STAFF RECOMMENDATION
1319 Fourth Avenue North
April 19, 2017

Application: New construction – outbuilding; Setback determination
District: Germantown Historic Preservation Zoning Overlay
Council District: 19
Map and Parcel Number: 08209017600
Applicant: Rob Williams
Project Lead: Paul Hoffman; paul.hoffman@nashville.gov

Description of Project: An application for an outbuilding with dwelling space behind the historic home, with a setback determination from twenty feet (20') to five feet (5') from the rear property line.

PRELIMINARY SITE PLAN

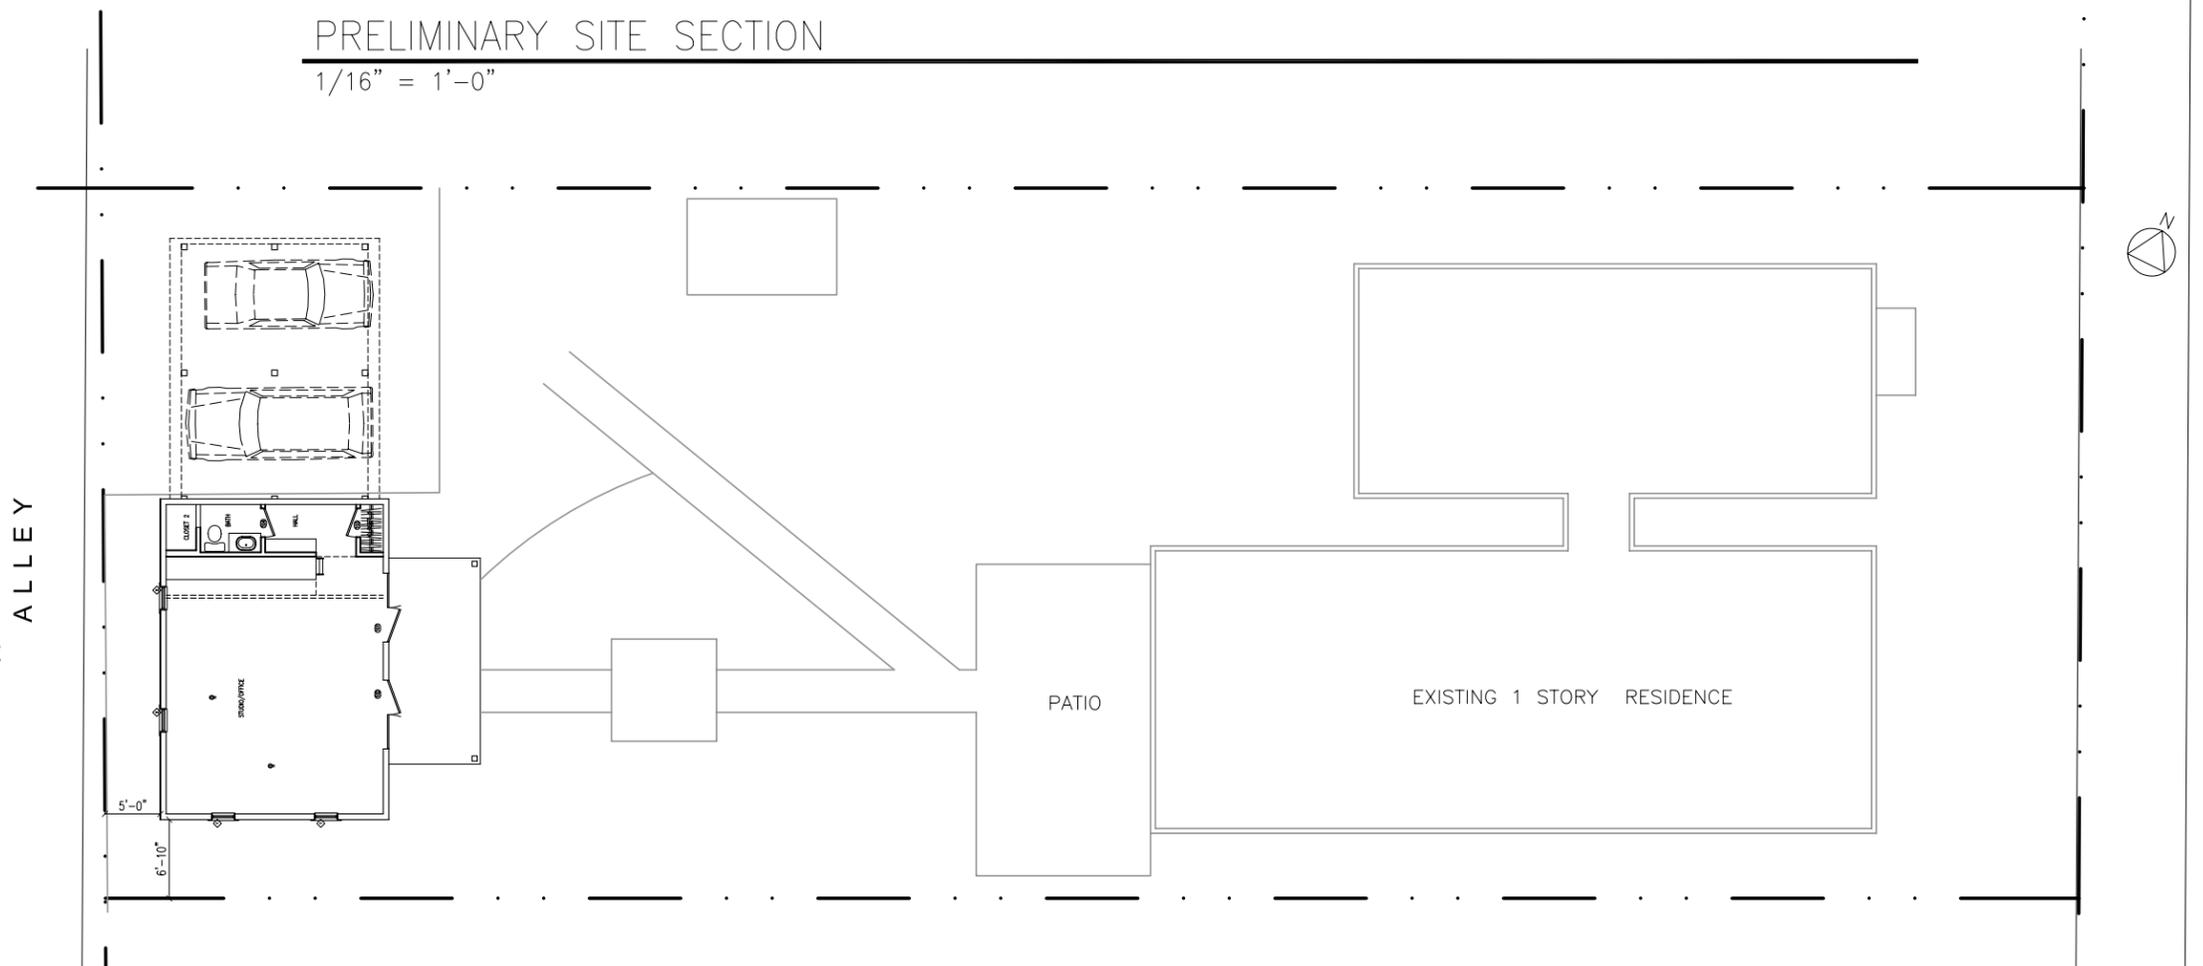
Location, Setback: The proposed outbuilding will be located at the rear of the property, approximately sixty-five feet (65') behind the house. The side setbacks are six feet, ten inches (6' 10") on the left and five feet (5') on the right. The bulk standards require a structure greater than seven hundred square feet (700 sq. ft.) to be twenty feet (20') from

the rear property line. This outbuilding is proposed at five feet (5') from the rear. Staff finds that the proposed setback determination is appropriate in this instance as outbuildings were historically located nearer to alleys than the current zoning requirements.

Staff finds the location and setbacks of the proposed outbuilding to meet Sections 2.9.2 and 2.9.3 of the *Germantown Historic Overlay Design Guidelines*.

A2.0 NORTH & SOUTH ELEVATION

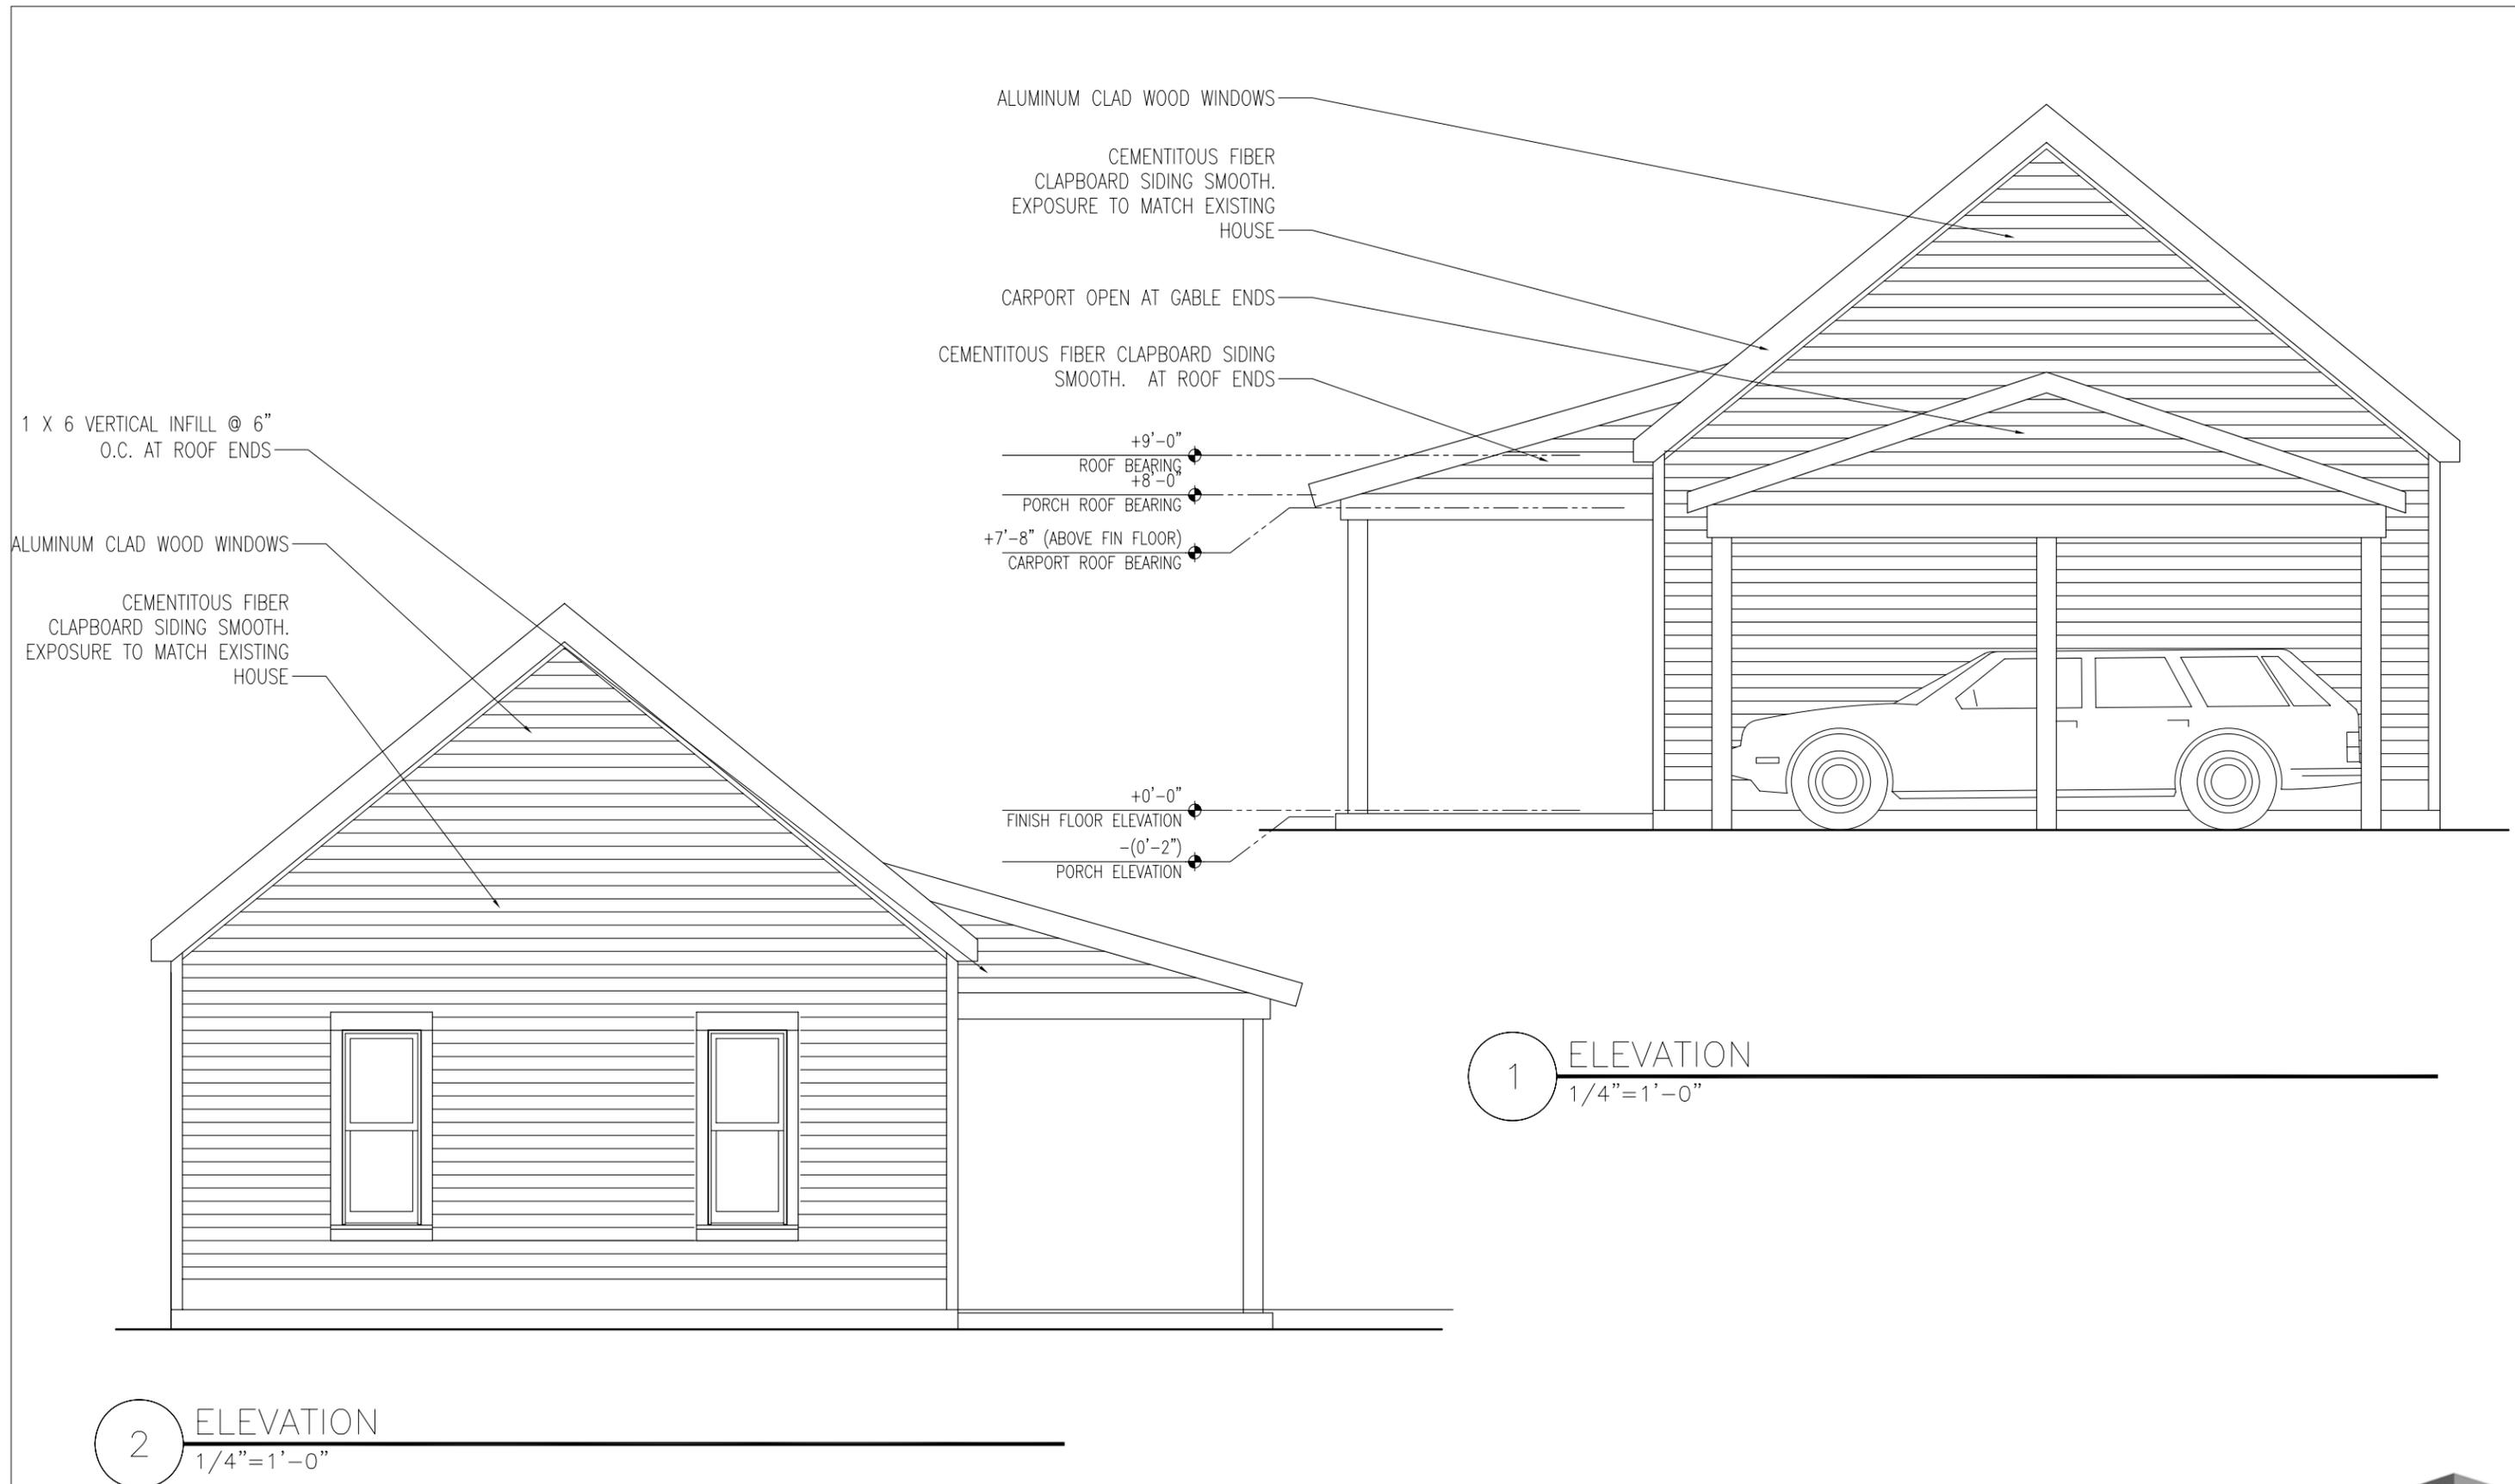
Height, Scale: The proposed outbuilding is one story with a ridge height of nineteen feet (19') and an eave height of nine feet, six inches (9' 6"). It will be subordinate to the principal building's overall height of twenty-one feet (21') and eave height of eleven feet (11'). The outbuilding consists of an enclosed portion with five hundred and sixty square feet (560 sq. ft.) and an attached carport which adds another three hundred and fifty-two square feet (352 sq. ft.). The covered porch is one hundred and twenty-seven square feet (127 sq. ft.) for a total covered footprint of one thousand and thirty-nine square feet (1,039 sq. ft.) which is less than half of the primary building's two thousand, two hundred and ninety-seven square feet (2,297 sq. ft.). Staff finds that the massing of the proposed outbuilding will be subordinate to the principal building and compatible with surrounding buildings.

Materials, Texture, and Details and Material Color: The proposed outbuilding will have a concrete slab-on-grade foundation with fiber-cement clapboard siding and a metal roof. The windows and doors will be aluminum-clad but details were not specified. Staff recommends having final approval of windows, doors and roofing color. Staff finds that the proposed materials are appropriate as they are common within the district.

Roof and Building Form: The outbuilding will have a side-gabled roof, a form that is common on outbuildings in the neighborhood historically. The primary roof has 9/12 pitch. The carport has 4/12 pitch. The porch has a lower-sloped shed roof with 3.5/12 pitch.

Proportion and Rhythm of Openings: The windows on the proposed outbuilding will be compatible with proportions or openings on historic buildings, which are generally twice as tall as they are wide. Staff finds the outbuilding’s proportion and rhythm of openings to meet Section 2.9.5. of the *Germantown Historic Overlay Design Guidelines*.

1. Staff approve the final window and door selections as well as the color of the roofing material prior to purchase and installation.
